Initial Study/Mitigated Negative Declaration

**BART Market Street Canopies
and Escalators Modernization Project**

Comments and Responses

Comments Received on the Draft IS/MND

Figure B

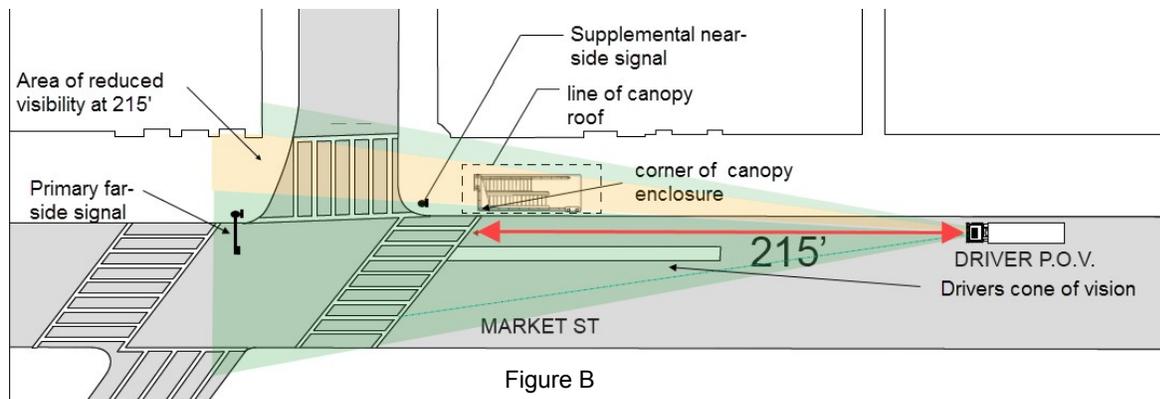
Two of the proposed canopies, #12 and #17, have existing near-side pole-mounted signals in addition to the required primary signal faces on near-side approaches. The MUTCD does not require a minimum visibility distance to supplemental signals. SFMTA best practices use the same distances for near-side signals as prescribed in Table 4D-1 of the MUTCD.

As illustrated in Figures B and C, canopy elements, including support columns and glass enclosures have the potential to obscure a driver's line of sight to the supplemental signal faces.

As such, proposed canopies #12 and #17 were modeled to assess signal and pedestrian visibility. Figures B and C show the Signal Visibility Model for canopy #12 illustrating the drivers' position and their cone of vision as they approach the intersection of Market Street and New Montgomery Street from the west. Canopy #12 represents the worst condition of the 22 canopies included in the proposed project.

BART will continue to work with SFMTA during final design and implementation of the proposed project to ensure the design of the canopies does not obstruct existing traffic signal or pedestrian sightlines or conflict with San Francisco's Better Market Street Project. No revisions to the Draft IS/MND are necessary as a result of this comment.

Figure D

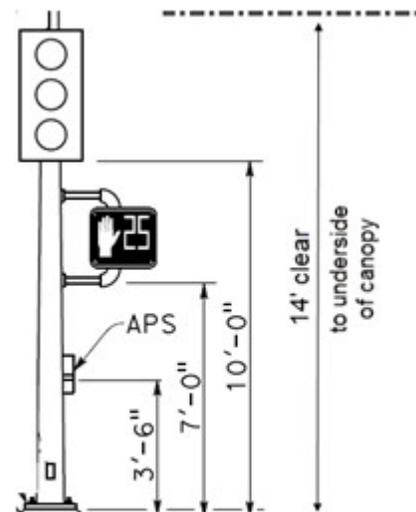
The Better Market Street project plans are still in development and the final placement of the curbs, crosswalks and signals is still unknown. Generally however, visibility to the near-side signal faces would not be obscured since the underside of the roofs of the canopies would be at least 14 feet above the sidewalk, and with the near-side signal faces mounted below that, the canopy overhangs would not impair a driver's vision to the signal face (see Figure D).

Additionally, the current proposal for the Better Market Street project includes the curb lines being moved toward the center of the roadway thereby increasing the sidewalk width and improving sight lines to the supplementary signals. This would also improve visibility of pedestrian queuing at the crosswalks. The proposed canopy enclosures would be transparent from the ground plane to the underside of the roofs which would provide maximum visibility, so further design changes are not necessary. As the plans for the Better Market Street project progress, placement of the near-side signals and crosswalks should be considered in conjunction with the proposed canopy enclosures.
